REMARKS

This application has been reviewed in light of the Office Action dated December 17, 2007. Claims 9-15 are presented for examination, of which Claim 9 is in independent form. Claims 1-8 have been canceled without prejudice of disclaimer of the subject matter presented therein, and new claims 9-15 have been added to provide Applicant with a more complete scope of protection. Favorable consideration is requested.

Appln. No. 10/586,386

[Fig. 001]

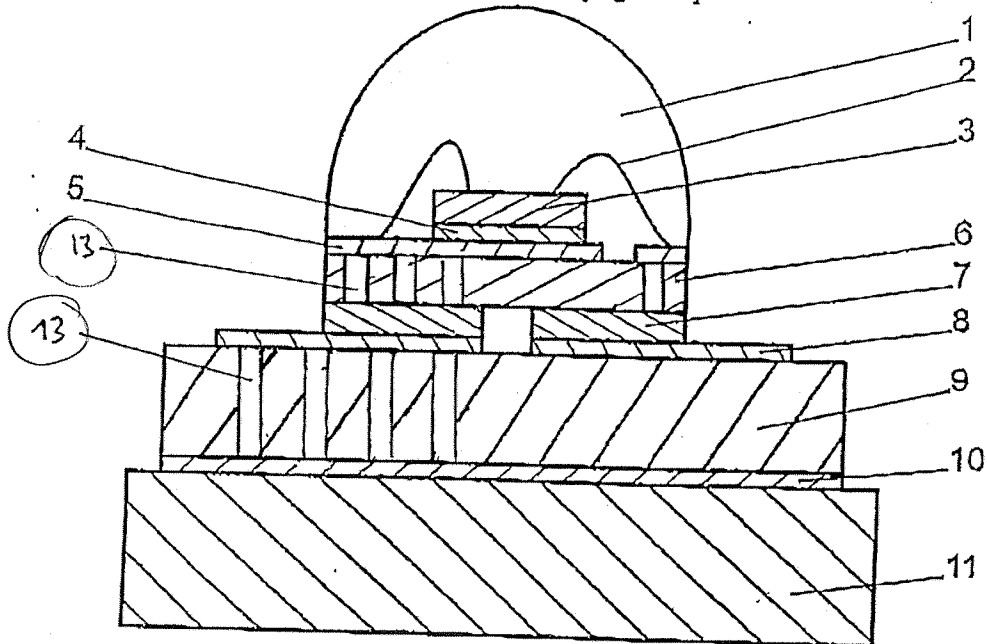
The drawings were objected to under 37 C.F.R. § 1.83(a) for allegedly failing to show every feature of the invention specified in the claims. In particular, the 'through-contacts' were deemed not shown in the drawings. Submitted herewith is an Annotated Drawing sheet showing changes to Figs. 1 and 3, as well as a Replacement Sheet of drawings incorporating the changes to Figs. 1 and 3. On the Annotated Sheet the reference numerals corresponding to changes to the drawings have been circled. In annotated Fig. 1, through-contacts 13 have been added. In annotated Fig. 3, through-contacts 13 and the insulation layer 14 have been added. Applicant submits that the amendments to the drawings add no new matter to the original disclosure, and support for the amendments may be found in the original specification (*see*, for example, paragraph [0019] with respect to the through-contacts). Approval of the amended drawings is respectfully requested. Applicant submits that the drawings are in compliance with 37 C.F.R. § 1.83(a) and that the objection has been obviated. Withdrawal of the objection is therefore respectfully requested.
